RESOLUTION NO. 892

A RESOLUTION OF THE CITY COUNCIL OF THE CITY OF GIG HARBOR, WASHINGTON, AMENDING THE WASTEWATER COMPREHENSIVE PLAN BY REVISING THE SEWER COLLECTION BASIN BOUNDARY BETWEEN SEWER COLLECTION BASINS #3 AND #17.

WASTEWATER
COMPREHENSIVE PLAN
AMENDMENT
FOR
EVERGREEN
BUSINESS CENTER

WASTEWATER COMPREHENSIVE PLAN AMENDMENT

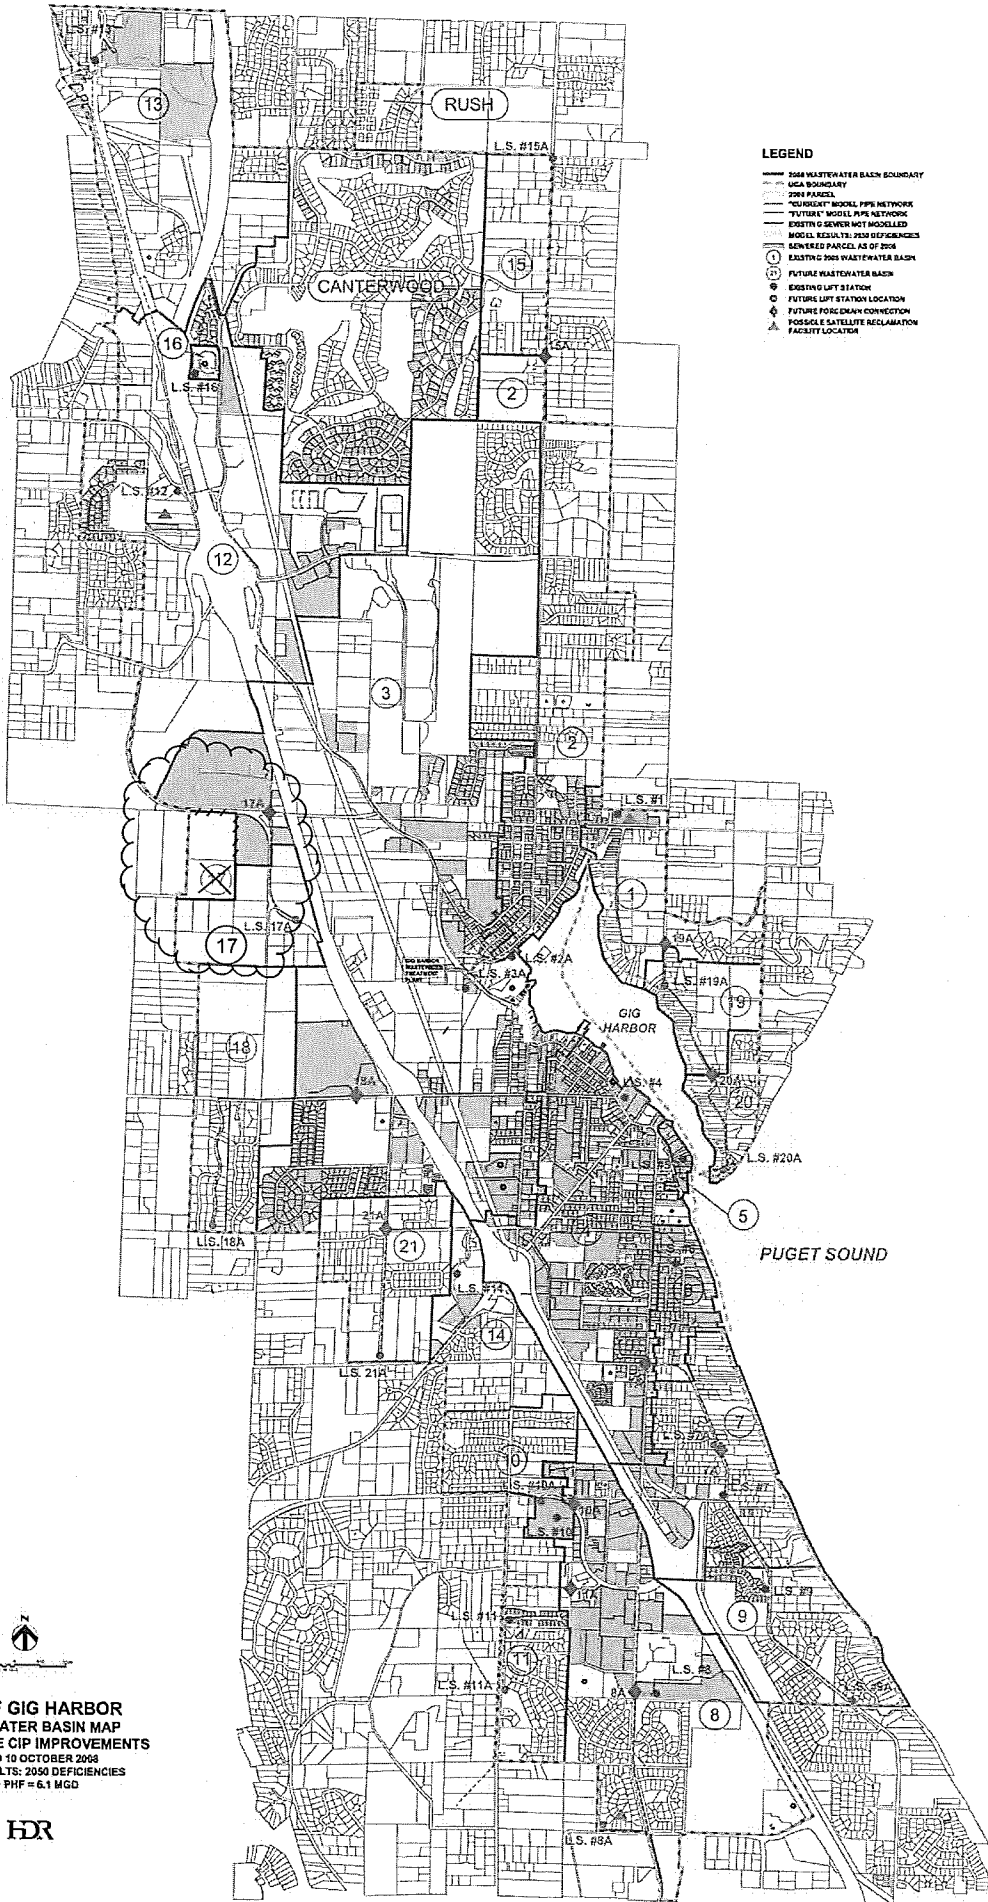
Due to timing, costs, and the fact there is another viable option via gravity flow, it is our proposal to modify the boundary line between Basin 3 and Basin 17 to now include the above mentioned parcels in Basin 3; refer to the revised Wastewater Basin Map attached. With all discharge being conveyed through Lift Station 3A, the reconfiguration of the demand from Basin 17 directly to Basin 3 should not adversely affect this lift station or the wastewater treatment plant. Since Lift Station 17A is still a future lift station, and according to the current Comprehensive Plan does not have a scheduled
